UNITED STATES PATENT AND TRADEMARK OFFICE

APPLICATION NO.	FILING DATE	FIRST NAMED INVENTOR	ATTORNEY DOCKET NO.	CONFIRMATION NO.
10/630,640	07/29/2003	William Dale Jones	SSI-08200	8274

Office Action Summary

Figure 1B

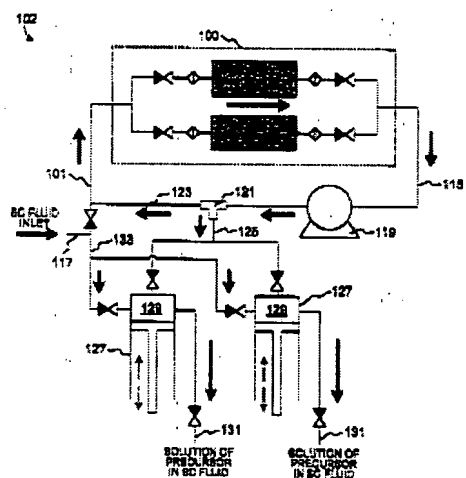
means (129, see fig. 1B) for injecting a processing chemistry (the fluid in line 115) into the system for supercritical processing, including means for starting and means (syringe pump 129, 129) for stopping the means for injecting wherein the means

for starting and the means for stopping comprises a flow-control means; and

means (check valve 131, see figs below) for substantially preventing fluid from re-entering the means for injecting during supercritical processing

means for injecting a second chemistry (col. 8, lines 25-33) for injecting a second chemistry into the system for supercritical processing, wherein the second chemistry is injected through an injection port separate from the means for injecting a processing chemistry into the system for supercritical processing, that differs from the claims only in the recitation of the flow control means being comprised of at least one of a valve, a pneumatic actuator, an electric actuator, a hydraulic actuator, and a micro-electric actuator. Although not shown in Gopinath, means must obviously be provide for the pump (120) to operate and is therefore considered to be inherent. Nonetheless, Japan'679 discloses that is old and well known to provide a control means as claimed. It therefore would have been obvious to one having ordinary skill in the art to modify the arrangement of Gopinath, to include control means as taught by Japan'679, for the purpose of precisely controlling the injection of the additive. In regard to the other fluids as claimed in claims 40-45; it should be noted that the device of Gopinath is structurally capable of employing various fluids depending upon the desired cleaning process.

Figure 1C

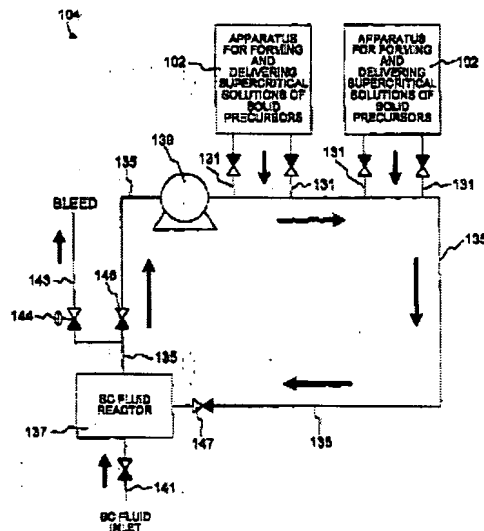
example, note that Gopinath discloses a supercritical processing system for processing a semiconductor wafer with a fluid (see abstract), the fluid being from a fluid source (as at 141, see fig. 1C), the system comprising:

- a. a circulation loop (135) coupled to a high-pressure processing chamber (137); and
- b. an inlet line (as at 131) for introducing the fluid into the circulation loop, the inlet line including:
 - i. an inlet port in the circulation loop;
 - ii. a back-pressure regulator (unnumbered check valve in line 131) coupled to the inlet port;
 - iii. a pump (119, see fig. 1B) for compressing the fluid to form a pressurized fluid;

iv. a first line (125) for transferring the pressurized fluid from the pump to the back-pressure regulator, the first line configured to maintain a uni-directional flow of the pressurized fluid from the pump towards the back-pressure regulator; and

v. a second line (101, 115, see fig. 1B) for transferring a quantity of the fluid from the fluid source to the pump, the second line configured to maintain a uni-directional flow of the fluid from the fluid source to the pump; and
